Ref: SFOBB, Skyway Project
Contract #04-012024
MSS Job #464
State Letter #5.03.1-009605 and 5.03.1-009608

Subject: MSS - NCR No. 34 - Weld Metal Not Conforming With Contract Specifications

Subject: MSS - NCR No. 33 - Weld Metal Not Conforming With Contract Specifications

Subject: Response to KFM-SUB-6315, Resolution to MSS - NCR Nos. 33 & 34 - Weld Metal Not Conforming With Contract Specifications

OUR REPORT NO: 1437GR

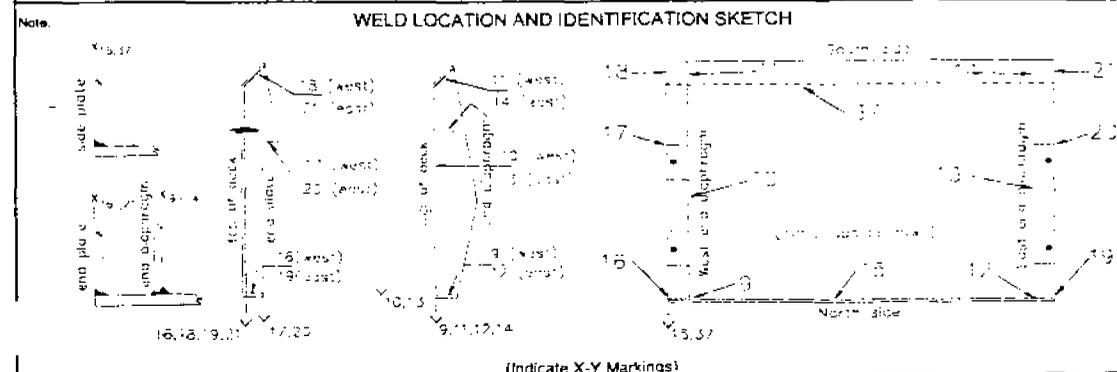
1. On 2-6-2006, bike path box panel mark 1437GR was found to have a "Class A" indication that exceeds AWS D1.5: 1996, Table 9.1 value. The rejection area is in the single bevel CJP weld #17 between 14 mm plate piece at 1437 and 16 mm plate piece at 1437.
2. On 2-9-2006, bike path box panel mark 1427XR was found to have a "Class A" indication that exceeds AWS D1.5: 1996, Table 9.1 value. The rejection area is in the single bevel CJP weld #13 between 16 mm plate piece at 1427 and 16 mm plate piece at 1427.

Mountain States Steel verified the indications noted by QA. MSS counseled the
responsible inspectors. After a conference call with MSS, KFM, Caltrans and Mets,
MSS employed Kevin Smith of QTI to perform remedial training for UT
technicians. The scope of this training was to discuss scanning patterns.
Caltrans/Mets onsite representatives were invited to attend.

OUR REPORT NO: 1438AR

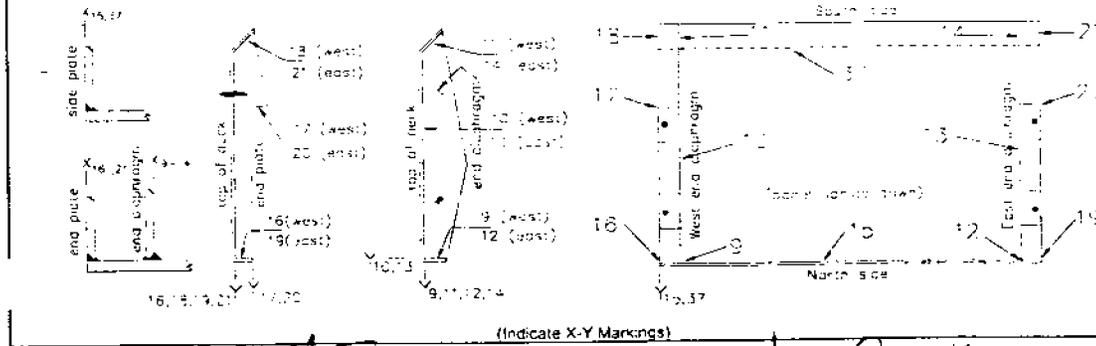
1. On 2-13-2006, bike path box panel mark 1438AR was found to have "Class A" indications in two separate welds that exceed AWS D1.5: 1996, Table 9.1 value. The first rejection area is in the single bevel CJP weld #20 between 14 mm plate piece ay1438 and 16 mm plate piece at1438. The second rejection area is in the single bevel CJP weld #13 between 16 mm plate piece ap1438 and 16 mm plate piece gt1438.
